SUBJECT: Responses to the Request for Additional Information
Regarding License Amendment Request to Update
the Reactor Coolant System Pressure-Temperature Limits
Arkansas Nuclear One, Unit 2
Docket No. 50-368
License No. NPF-6

Response to Request for Additional Information (RAI)

Reactor Coolant System Pressure-Temperature Limits

RAI-1 – Low Temperature Overpressure (LTOP) Peak Pressure Determination

Figure 1: LTOP Valve Inlet Pressure and Backpressure

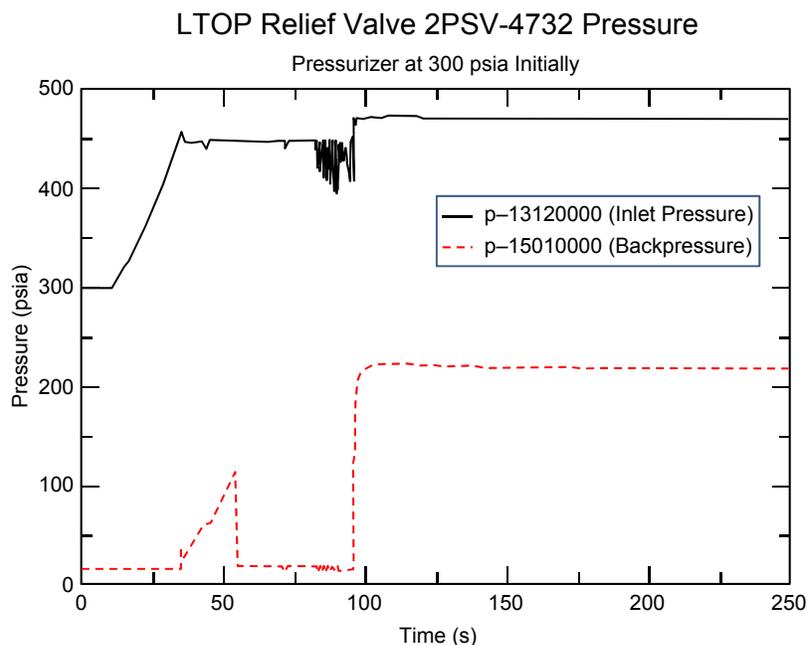
Please explain how the RELAP5-based pressures versus relief valve flow were used in the LTOP reanalyses for the mass and energy addition events. If the RELAP5-based pressure-flow data for both steam and liquid discharge were used in the peak pressure determination as an input to CENTS or RELAP5, please explain the criteria used to determine when to switch-over from the pressure-flow data for the steam discharge to the pressure-flow data for the liquid discharge. During the transition from the steam discharge to the liquid discharge, the discharge of the mixture of the steam and liquid may occur. Please discuss and justify how the RELAP5-based pressure-flow data were used in the LTOP for the discharge of the steam-liquid mixture.

In developing the RELAP5 pressure-flow data, the fluid in the pressurizer is compressed by an influx of fluid (at the initial pressurizer saturation temperature) through the pressurizer surge line. The LTOP relief valve starts to open at 3% overpressure (457.6 psia) of the valve's lift set pressure of 430 psig (444.7 psia). Initially, steam flow is discharged through the valve followed by a steam-water mixture, and finally water. The valve opens at about 35 seconds by discharging steam through the valve.

Subsequently, a two-phase mixture is discharged from about 82 seconds to 100 seconds followed by water. Peak inlet pressure occurs during water discharge. The valve inlet pressure and backpressure are shown in Figure 1. The relief valve flow versus backpressure characteristics are developed based on these RELAP5 pressurizer insurge evaluations including the relief valve developed backpressure and the effect of backpressure on pressure-flow data during the discharge of a two phase mixture. Initial pressurizer saturation temperatures corresponding to 300 psia and 400 psia were used to develop the pressure-flow data.
